**Safety Evaluation Report
License Amendment for the Jane Dough Unit at the
Nichols Ranch In Situ Recovery Project
in Johnson and Campbell Counties, Wyoming**

Materials License No. SUA-1597

URANERZ ENERGY CORPORATION

Figure 1. Stratigraphic Column in Jane Dough Unit
(adopted from Figure JD-D5-2, "Stratigraphic Column," of Uranerz 2014f)

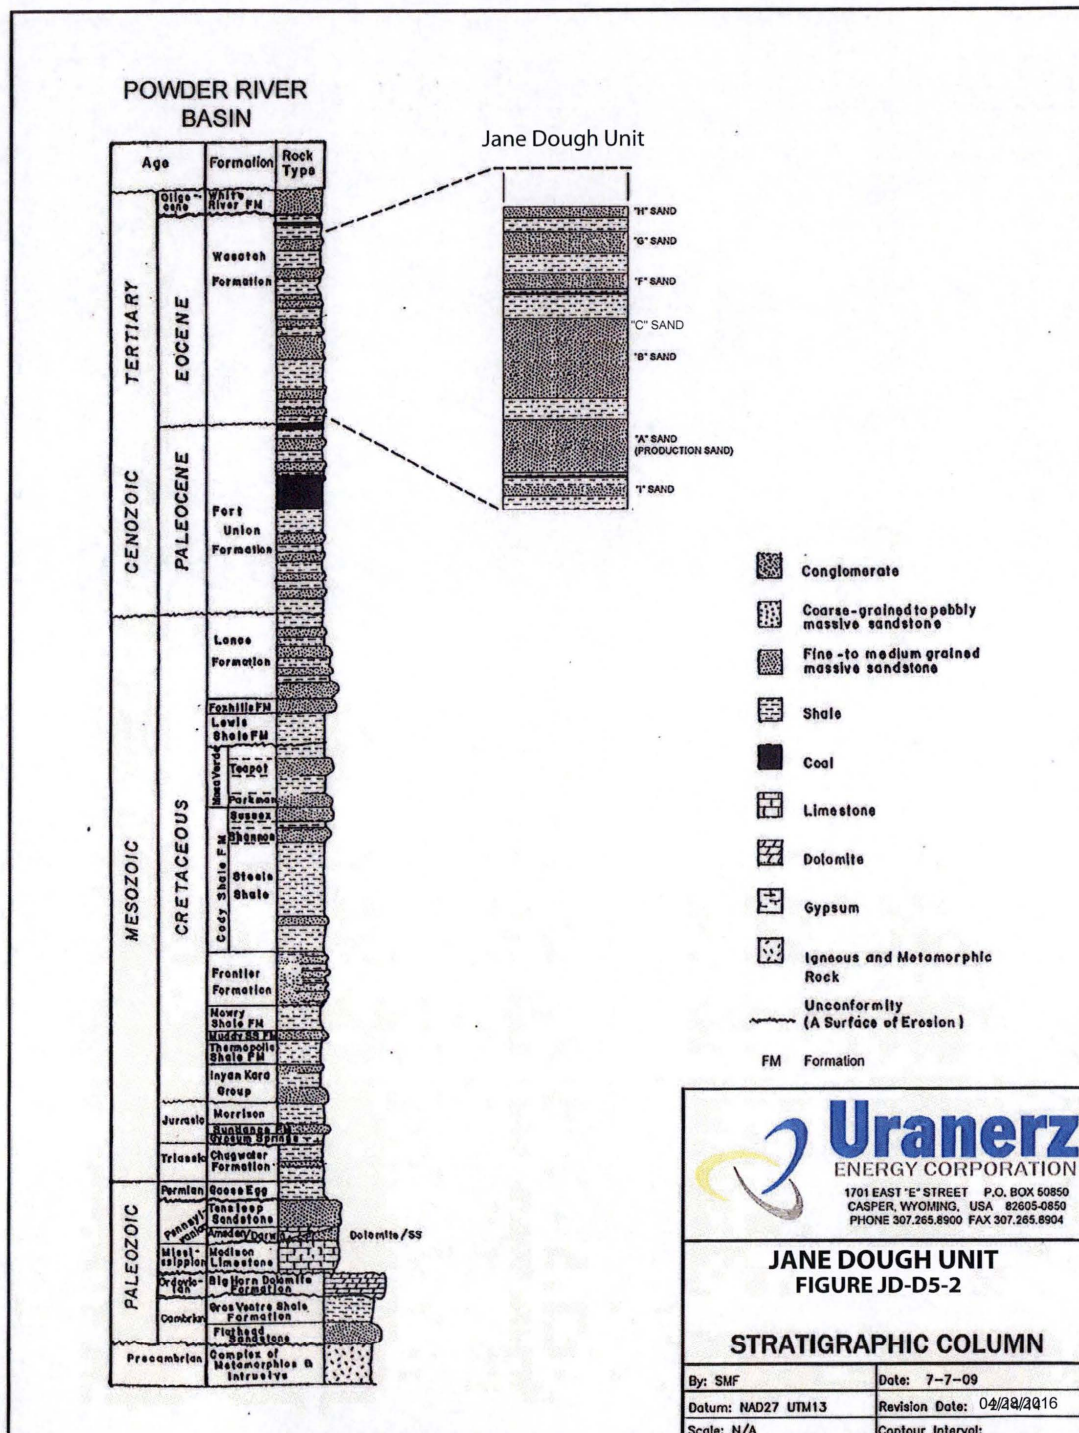
The licensee identified eight fluvial sandstone horizons. The licensee referred to these horizons from shallowest to deepest as, the H, G, F, C, B, A and 1 Sands (see SER Figure 1) and further indicated that the notable sand units (i.e. the thicker and more aerially extensive units) are the G, F, B, A and 1 Sands. The licensee indicated that the Jane Dough Unit sands are stratigraphically the same as those at the currently licensed Nichols Ranch Unit.

The NRC staff finds the licensee's description of the site geology is generally consistent with that provided for the Nichols Ranch Unit which NRC staff previously found acceptable (NRC 2011a). Moreover, the NRC staff finds that the licensee's characterization of the site geology is consistent with the acceptance criteria in SRP Section 2.6.3, "Acceptance Criteria" (NRC 2003).

Figure 2. Potentiometric Surface of the Jane Dough Unit A Sand Aquifer in 2013 (elevation in feet, modified from Jane Dough Technical Report Figure JD-D6-5)

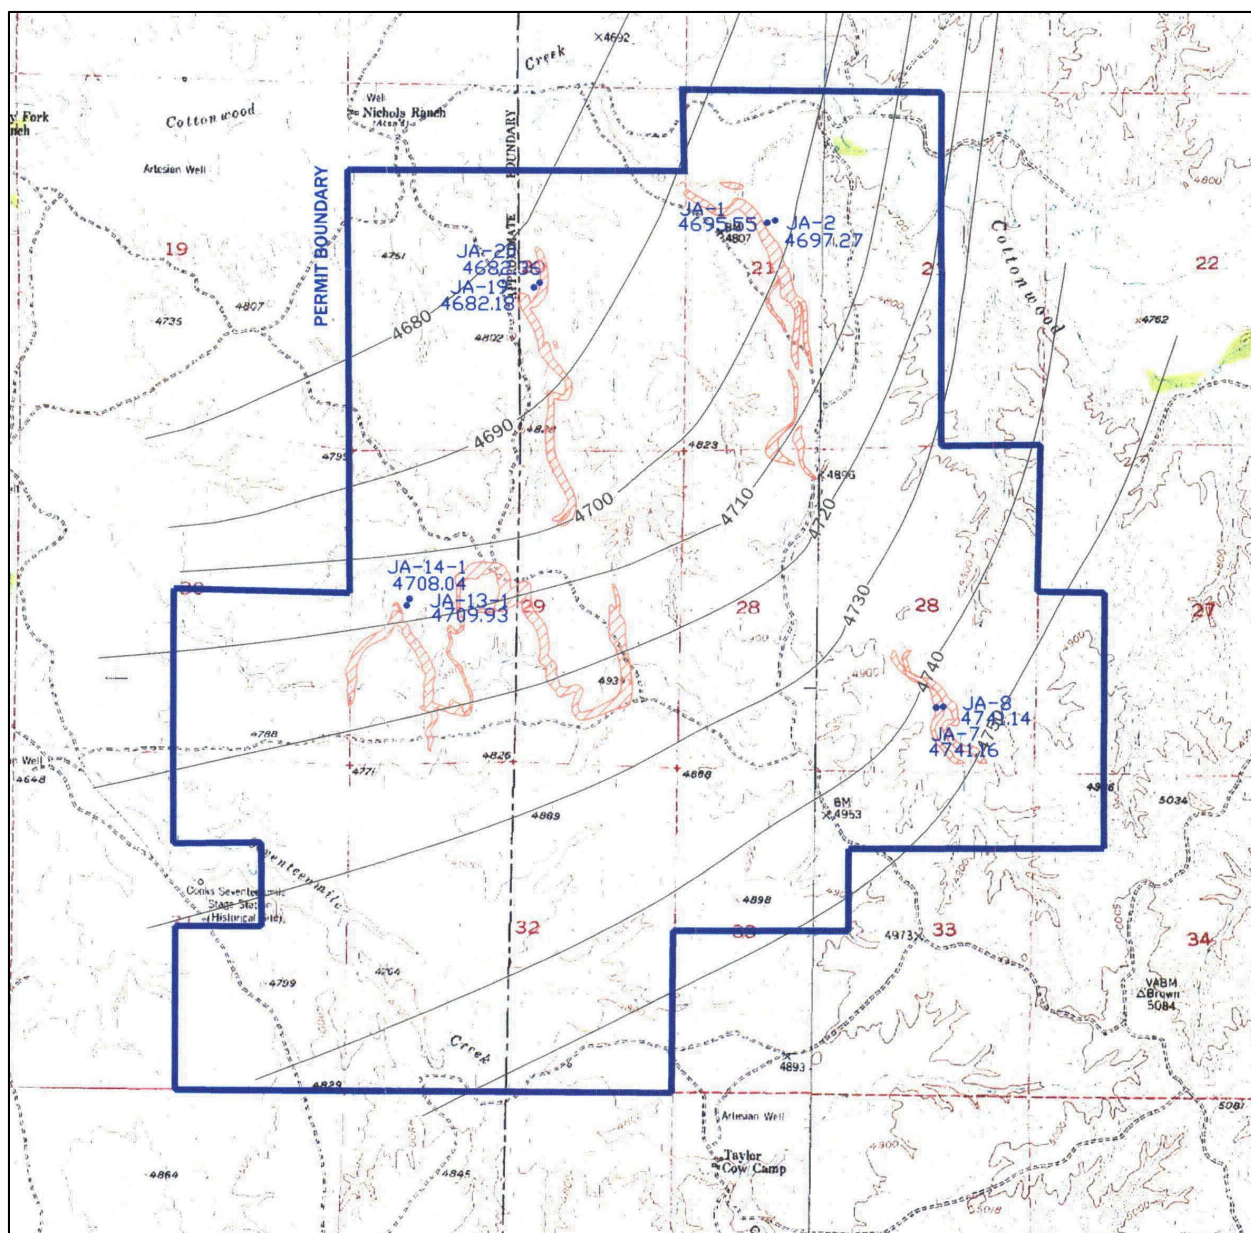
The A Sand is the ore production zone and is continuous over the majority of the Jane Dough Unit with thicknesses ranging from 15.2 to 30.5 m (50 -110 ft). The licensee used 8 wells, as shown in SER Figure 2, to measure water levels in the A Sand. Water level measurement in the A Sand demonstrate that the aquifer is confined, with a potentiometric surface rising approximately 61 – 91.4 m (200 - 300 ft) above the top of the sand unit.

Based on the potentiometric contours, the licensee reported the groundwater flow direction is to the northwest with a gradient of 0.0064 m/m (0.0064 ft/ft). Using this gradient, an effective

porosity of 0.05 and an average hydraulic conductivity of 0.08 m/day (0.25 ft/day), the licensee calculated an average A Sand groundwater flow velocity of 3.7 m/yr (12 ft/yr).

Figure 3. Jane Dough Unit Stock Wells and Domestic Wells

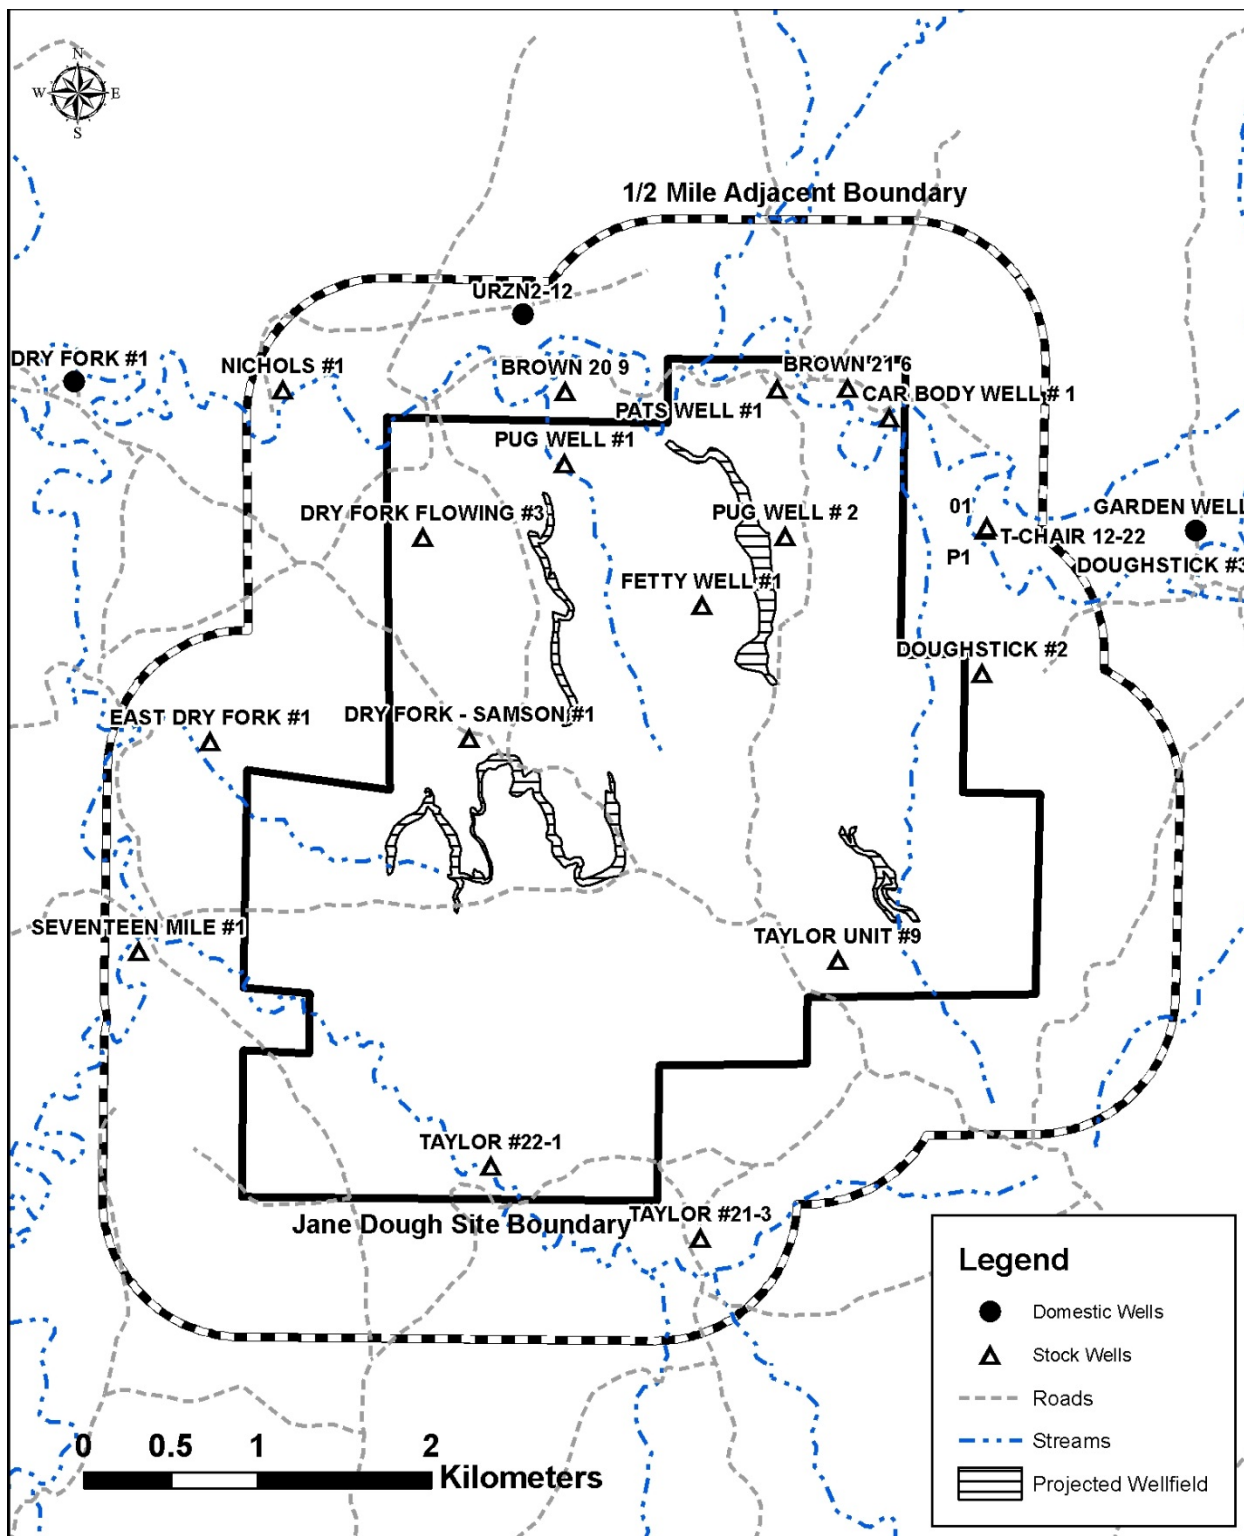
SER Figure 3 presents the locations of stock wells and domestic wells located within 0.8 km (0.5 mi) and 5 km (3 mi), respectively, of the Jane Dough Unit. Note that wells P1, 01 and T-CHAIR 12-22 are in close proximity and appear as a single symbol on SER Figure 3. Similarly, wells Doughstick #3 and Garden Well appear as a single symbol on SER Figure 3.

Based on NRC staff review of the Wyoming e-permit database, the average appropriation for the wells presented in SER Figure 3 is less than 38 Lpm (10 gpm).
